AMENDMENT NO. 1 JUNE 2011
TO
IS 9435 : 2004 TERMS AND DEFINITIONS RELATING TO DIMENSIONS
OF ROAD VEHICLES OTHER THAN 2 AND 3 WHEELERS

(First Revision)

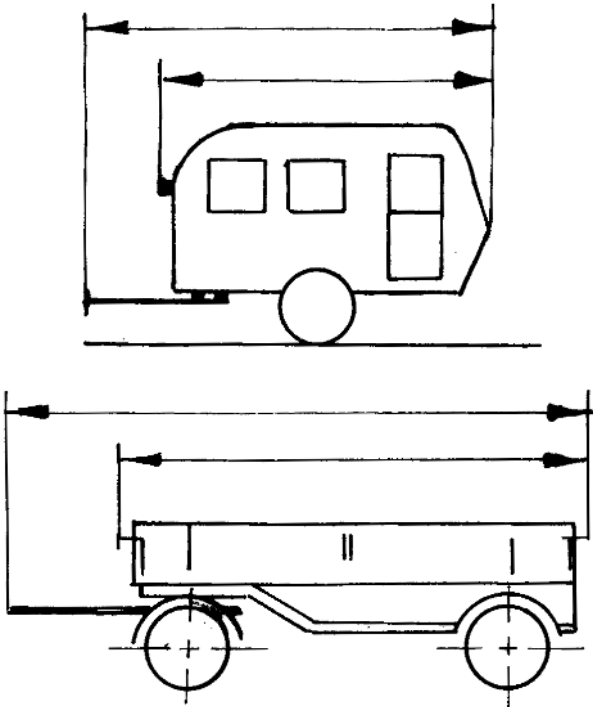
(Page 3, clause 5.1.1) — Add following new definitions after 5.1.1:

Clause	Term	Definition	Drawing
5.1.2	Trailer Length	The lengths with and without drawgear, defined as in 5.1.1, the second value being placed in parentheses: <i>Example</i> : 5500 (3700) NOTE — To determine the length with drawgear, the drawbar is assumed to be located so that the axis of the drawbar eye or coupling head is vertical and lies within the foremost vertical plane.	
5.1.3	Semi-Trailer Length	The length of the semi-trailer, defined as in 5.1.1, and the distance between kingpin axis and rear end of semi-trailer, the second value being placed in parentheses: <i>Example</i>: 10800 (7800)

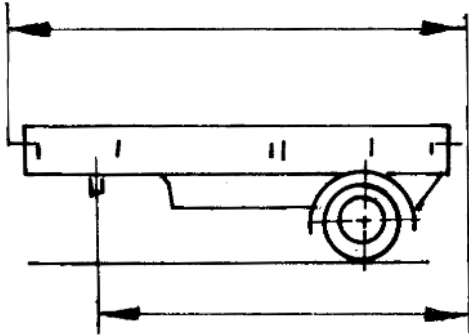
(Page 4, clause 5.4.1) — Add following new definitions after 5.4.1:

Clause	Term	Definition	Drawing
5.4.2	<i>Semi-Trailer Wheel Base</i>	The distance from the axis of the fifth wheel kingpin in a vertical position to the vertical plane through the axis of the semi-trailer's first axle. NOTE — In the case of a semi-trailer with two or more axles, the same rule should be applied as for vehicles with three or more axles.

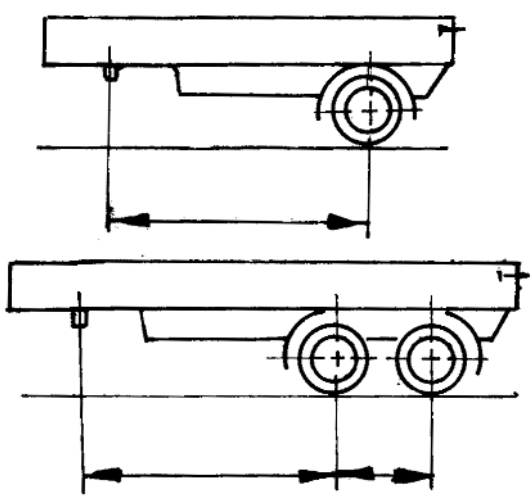
(Page 6, clause 5.12) — Substitute the following for the existing definitions and drawing:

Clause	Term	Definition	Drawing
5.12	<i>Height of Chassis Above Ground (Commercial Vehicles)</i>	The distance from the ground to the horizontal line perpendicular to the longitudinal median plane (of the vehicle) (<i>see 4</i>) and touching the upper surface of the chassis measured at the axle centre line. NOTES 1 in the case of vehicles with more than two axles, the distance is measured at the outermost axles (excluding lifting axles). 2 The height of the chassis above the supporting surface should be determined not only with the vehicle loaded to its maximum authorized gross vehicle weight (GVW) but also with the vehicle unladen.
